*Date:* September 14, 2023  
*Case No.:* **2019-020115ENV**  
*Project Title:* **Ocean Beach Climate Change Adaptation Project**  
*To:* Members of the Planning Commission and Interested Parties  
*From:* Lisa Gibson, Environmental Review Officer  
*Re:* Responses to Comments on the Draft Environmental Impact Report for the Ocean Beach Climate Change Adaptation Project

RESPONSES TO COMMENTS

# Ocean Beach Climate Change Adaptation Project

Case No. **2019-020115ENV**

**Revised Figure 2-2**  
Conceptual Rendering of Project Elements  
Proposed for South Ocean Beach

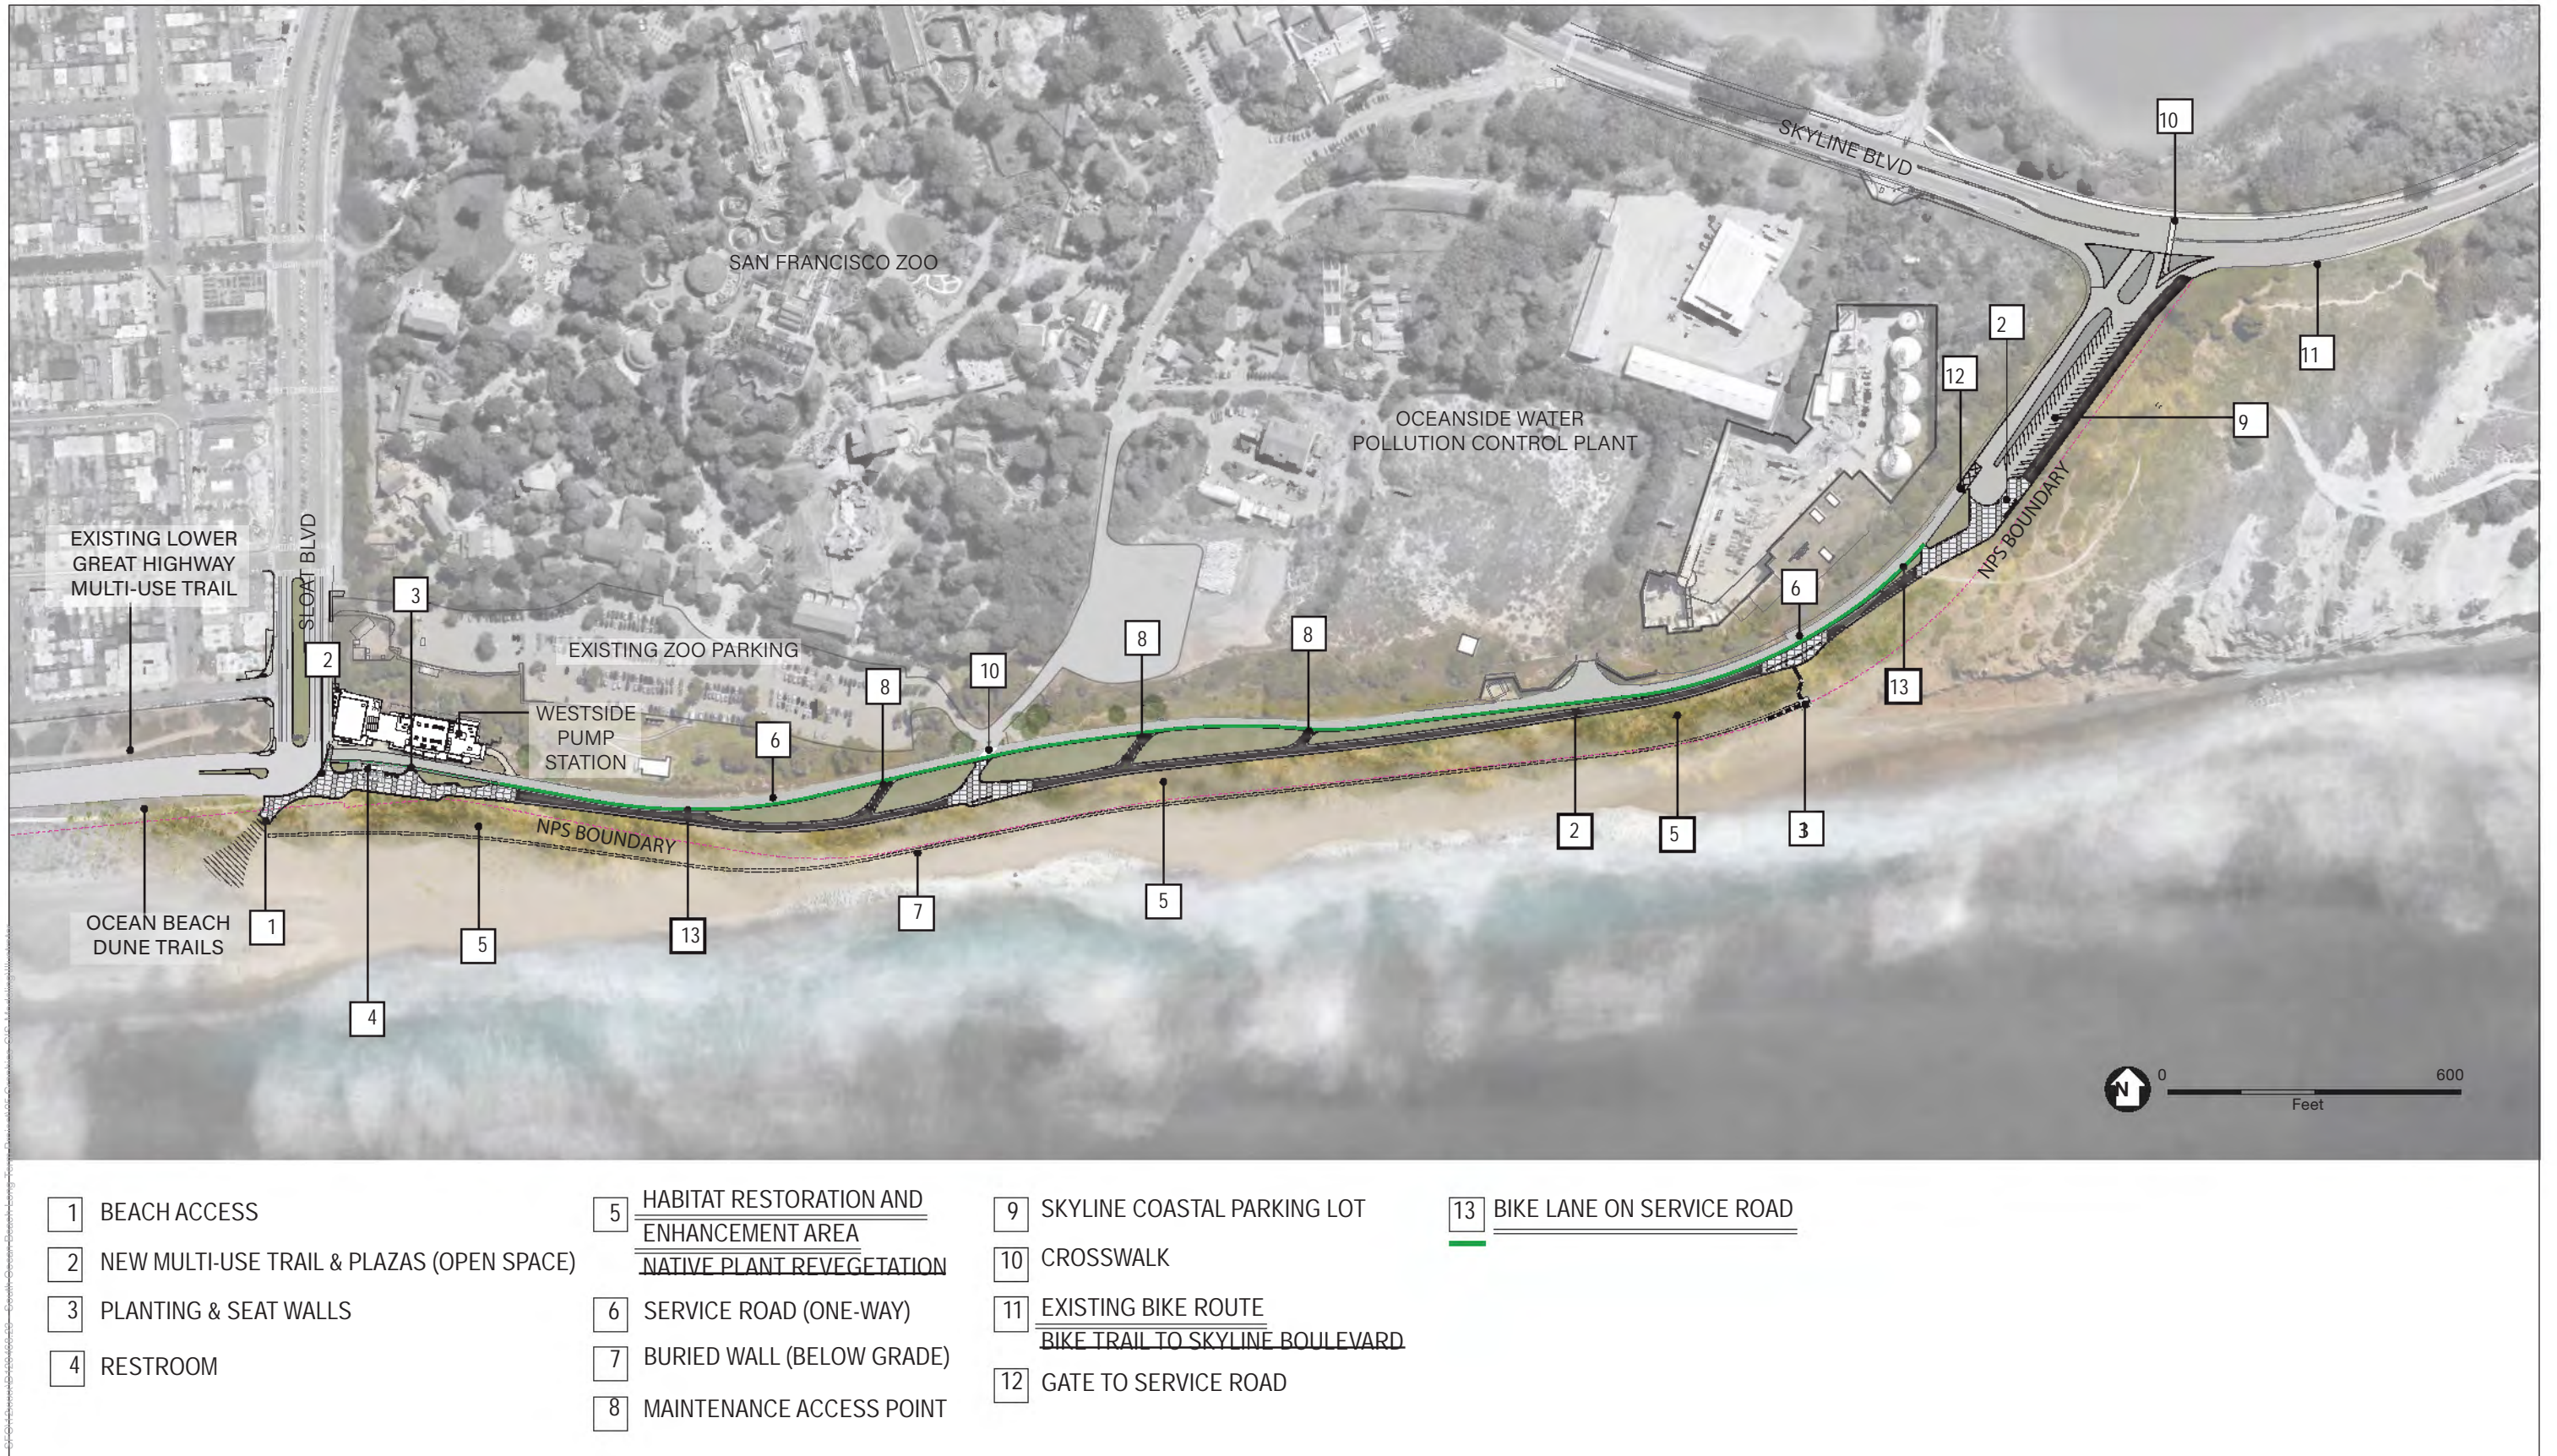
“In section -- excuse me in figure 2.2, which is on page 2.6, the markers for the trail point to the plazas at both ends and I assume the trail is the green line that goes from one parking plaza to the other one, but there's no legend that would indicate that and so I think if the green line is intended to be the trail, there should be a legend that indicates that.” (Sue Diamond, Commissioner, San Francisco Planning Commission [A-CPC-1.3])

Draft EIR **Figure 2-2** has been revised as shown on p. 12-31 of this RTC document to include a label identifying the green line as a designated bicycle lane along the service road. Figure 2-2 labeling has also been revised for consistency with project description revisions described in Chapter 9 of this RTC.
